SERVICE BULLETIN

FUJI HEAVY INDUSTRIES LTD.

NO : FAS-045

1. SUBJECT : Improvement of Rear seat backrest
2. AIRCRAFT AFFECTED : FA-200 Series Serial Nos. 12 thru 100.
3. PRIORITY : Desirable.
4. REASON : To facilitate battery inspection and maintenance Rear seat backrest is improved to "lift up mechanism type."
5. DESCRIPTION : Rear seat backrest assy to be replaced.
6. ACCOMPLISHMENT : Optional.
7. APPROVAL : JCAB Approved.
8. PART REQUIRED : The following parts are required to perform the rework.

DETAIL E'

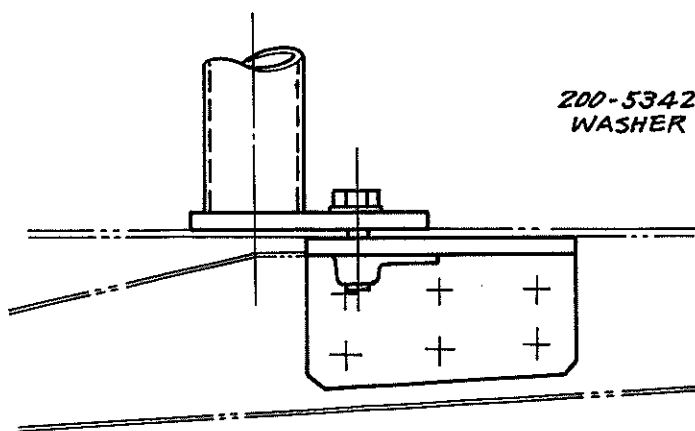
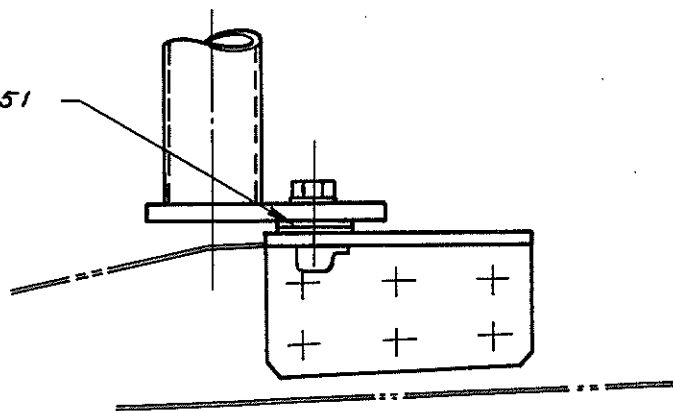
- (7) Remove the nutplate, attached to rear seat backrest fitting bracket, 200-534275-045 and -046. Move the nutplate position 2mm toward nose direction. (See Detail E').

MOVE HOLE POSITION 2^{mm}
TOWARD NOSE DIRECTION
